SAN ONOFRE NUCLEAR GENERATING STATION (SONGS) MITIGATION PROGRAM:

Executive Director's Determination that the Preliminary Mitigation Reef Plan Meets the Requirements of the SONGS CDP #6-81-330

Exhibit 3: Commission Comment Letter to
SCE on Preliminary Reef Plan Design

Exhibit 2: Layout of the proposed Wheeler North Reef off San Clemente, CA. Polygons in the offshore inset indicate the locations of the quarry rock modules.

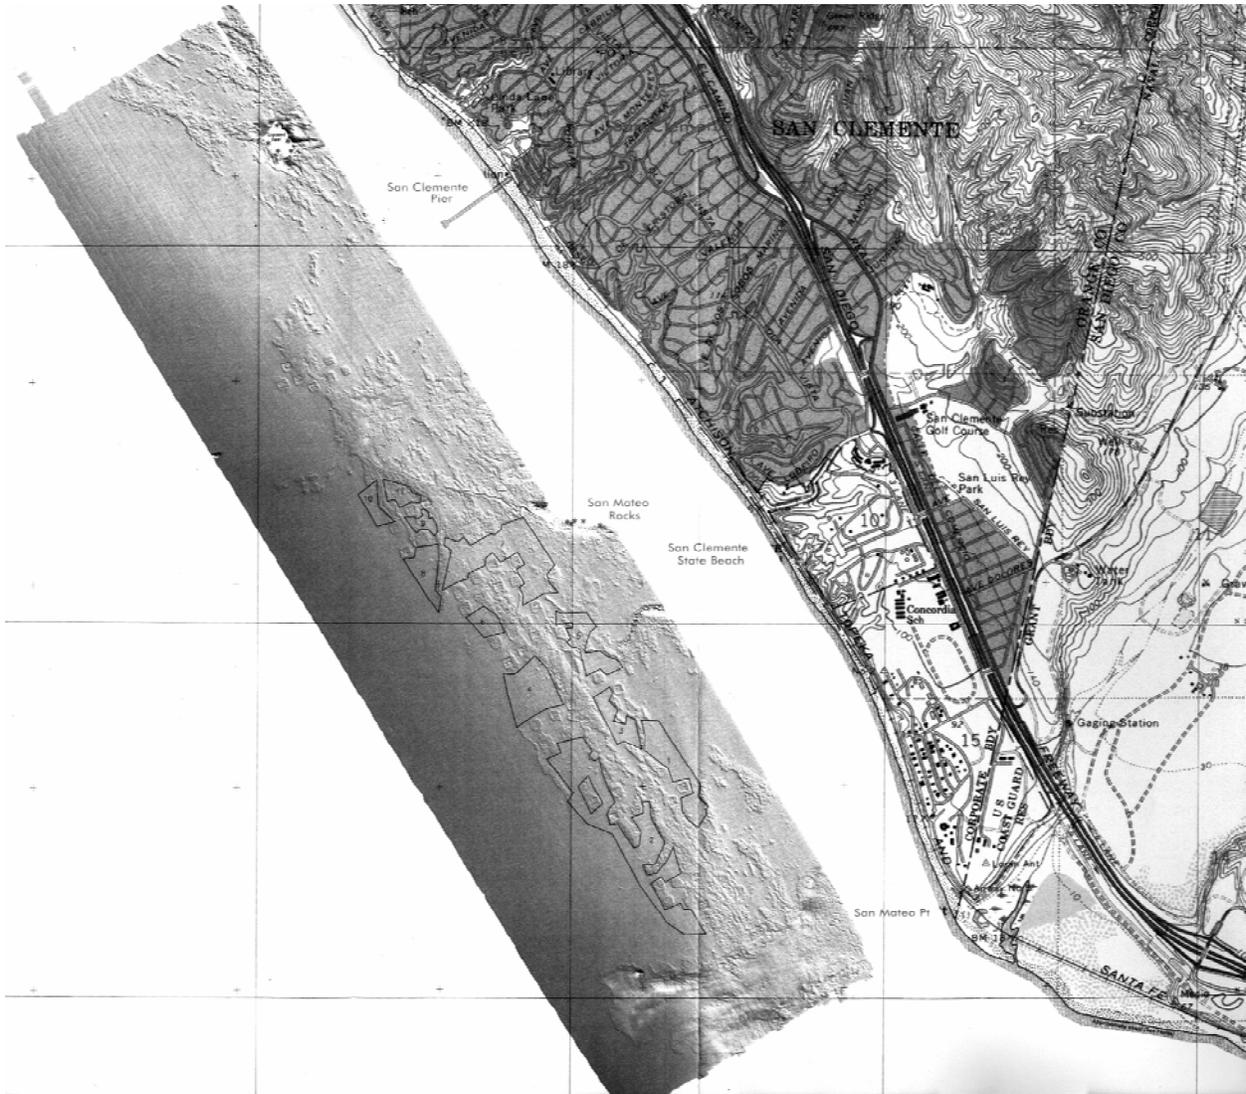
- The final plan should be accompanied by data files (e.g., GIS maps and layers) that allow the acreages of the polygons to be verified.
- The proposed 7 ± 1 m margin from existing modules and other hard substrate seems to be beyond the limits of the methods used to construct the experimental reef modules. Construction protocols should be the same as those used to construct the low coverage (i.e., 42%) quarry rock modules of the experimental reef. The experimental reef was not built to ± 1 m accuracy. Should SCE decide to implement this higher accuracy in constructing the mitigation reef, then the Final Plan Design should include rationale for this higher accuracy and some proof of concept that the construction methods proposed will indeed achieve the stated accuracy.

- The final plan should be accompanied by data files (e.g., GIS maps and layers) that allow the acreages of the polygons to be verified.
- The proposed 7 ± 1 m margin from existing modules and other hard substrate seems to be beyond the limits of the methods used to construct the experimental reef modules. Our understanding from discussions this year and last summer was that the construction protocols would be the same as those used to construct the low coverage (i.e., 42%) quarry rock modules of the experimental reef. The experimental reef was not built to ± 1 m accuracy. Should SCE decide to implement this higher accuracy in constructing the mitigation reef, then the Final Plan Design should include rationale for this higher accuracy and some proof of concept that the construction methods proposed will indeed achieve the stated accuracy.
